From: Perry, Graham <Graham.Perry@uuplc.co.uk>
Sent: 03 August 2021 22:37
To: Marta Wolska
Subject: RE: Repeat PDE 4200021415 Hammerstone Road Depot, Gorton, Manchester

From: Wastewater Developer Services
Sent: 01 July 2021 16:14
To: Perry, Graham <Graham.Perry@uuplc.co.uk>
Subject: Repeat PDE 4200021415 Hammerstone Road Depot, Gorton, Manchester

Subject: RE: PDE UU Ref: 4200021415 Hammerstone Road Depot, Gorton, Manchester

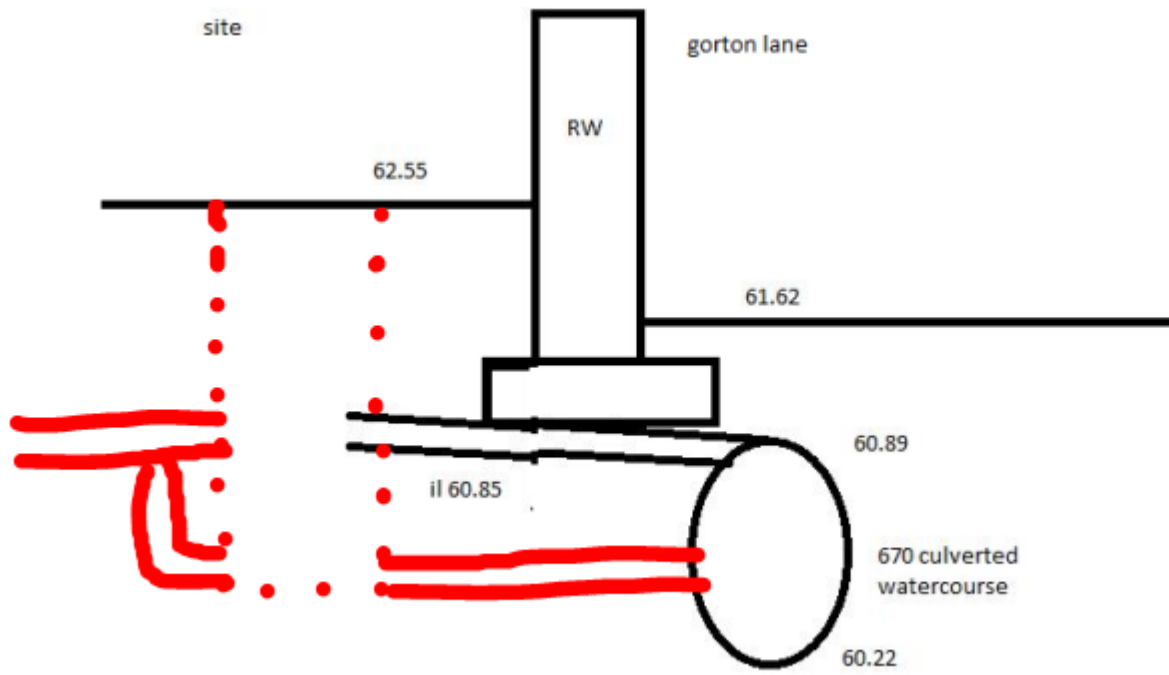
Rather than discount a connection to the culverted watercourse have you considered an offset manhole connection and then underpin the wall and put a lintel over the pipe passing through?

Also I cannot accept that you cannot gain access to the culvert because you could simply break out the existing cover using a jack hammer and then reinstate when finished.

I will only consider a connection to the combined sewer when all other avenues have been exhausted.

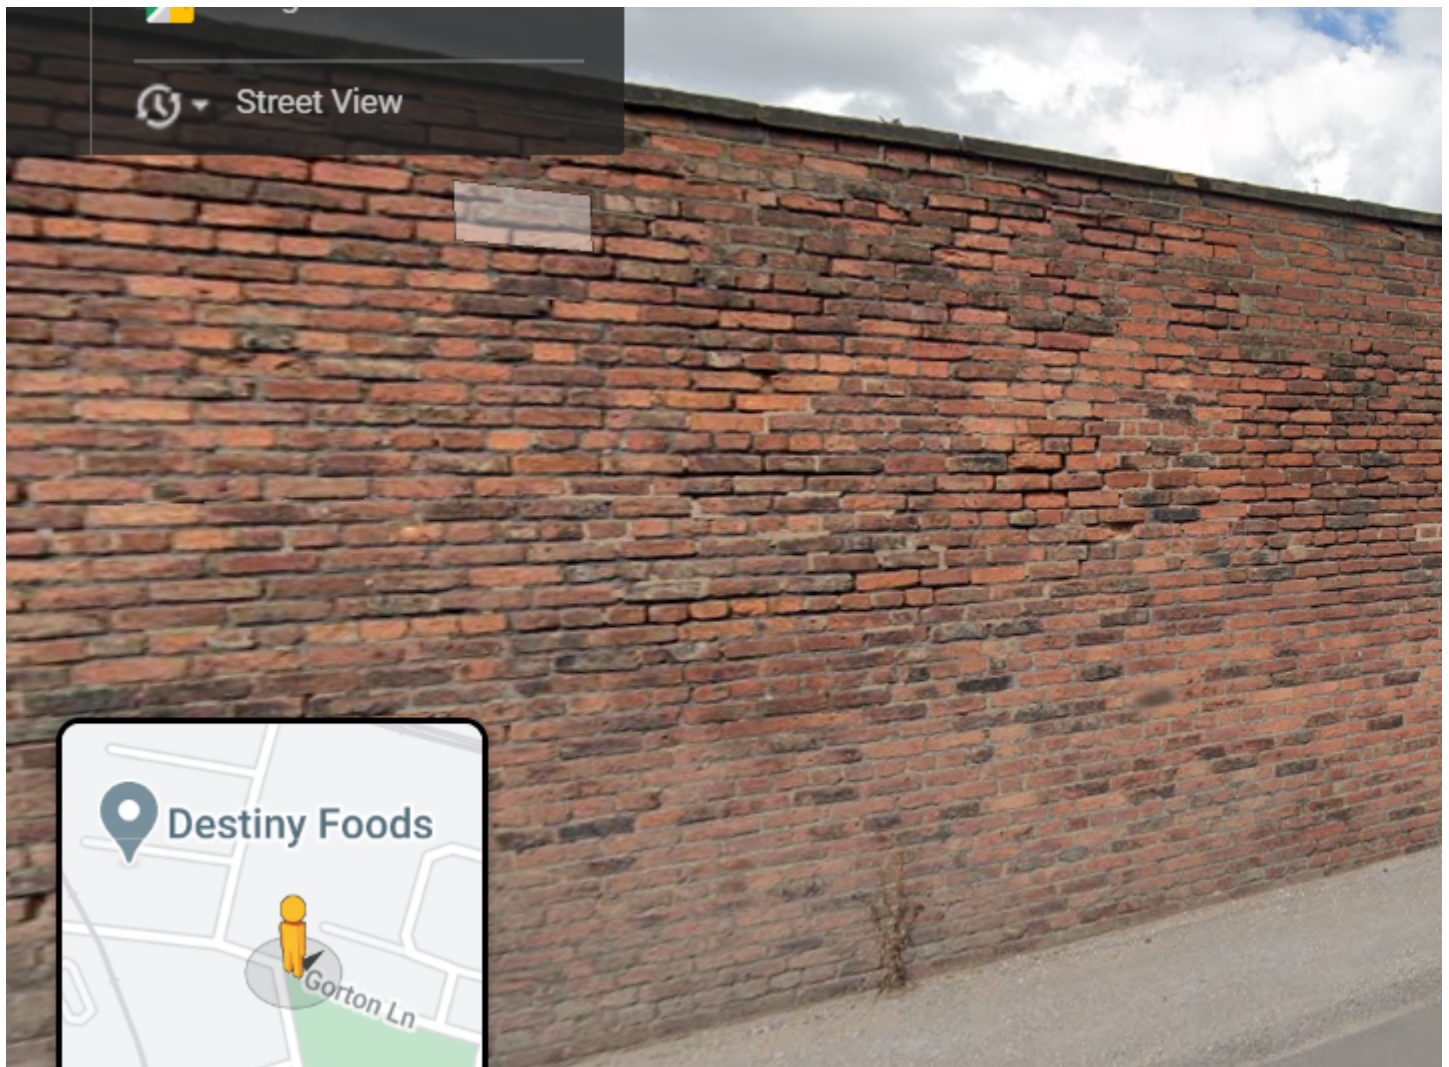
The existing south car park and existing building discharge currently to a combined water sewer within Gorton Lane. The southern culverted watercourse based on UU records runs under and near existing retaining wall. The southern culverted watercourse could not be traced as the covers could not be lifted using hydraulic lifters. Based on UU records the culverted watercourse is quite shallow, invert level is 1.4mbgl, whereas soffit 0.73m. The expected bottom of retaining wall foundation is 0.60mbgl, which means that proposed pipe soffit will be straight below existing retaining wall foundation.

The condition of the retaining wall is clearly in a state of disrepair and as such any works carried out to the wall may affect the ongoing structural integrity of the wall itself which may extend beyond the localised works required to form any new connection. Coupled with this, there is the ongoing maintenance of the pipe work between site and the culvert

which must be considered - any settlement to the wall at a critical drainage location could damage the pipe and affect the performance of the overall drainage system to the wider site.

This would also cause major issues with the foundations to the wall and the depth of the connection

We propose to reuse the existing connection from lower car park to combined water sewer.

As per attached drawing 506 and 505, the proposed surface water from lower car park has been restricted to 50% reduction of existing 1 in 1 year storm event to all storm events, which is 7 l/s, area C.

Given the concern about the potential instability of the retaining wall I would be willing to accept a discharge into the combined sewer a maximum discharge rate of 7 l/s

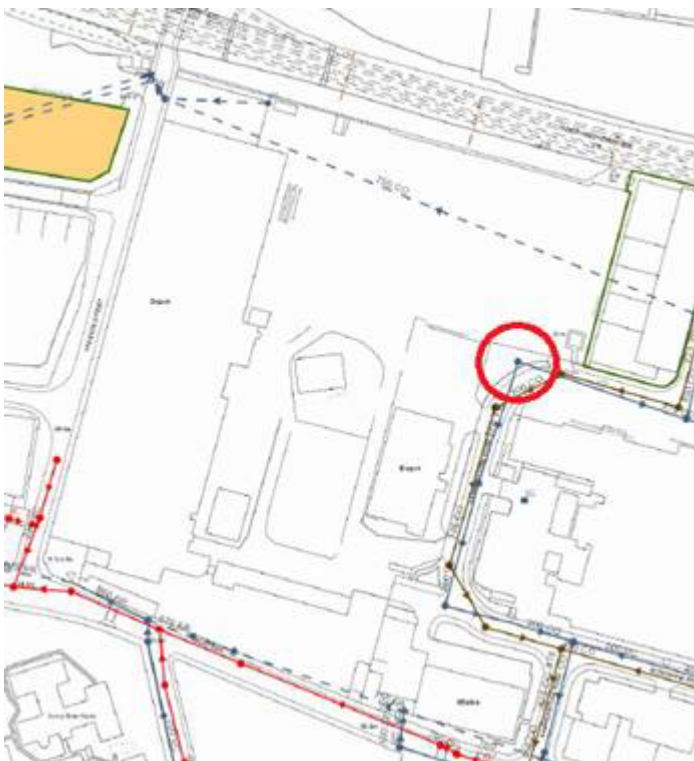
Please could you confirm potential to discharge, any limitations, any historic flood data for the site, as well as any sewer easement requirements for the 225/375 surface water sewer which encroaches into the site as circled below.

It's subject to standard Building Regs Part H so 3m from the centreline of the sewer,
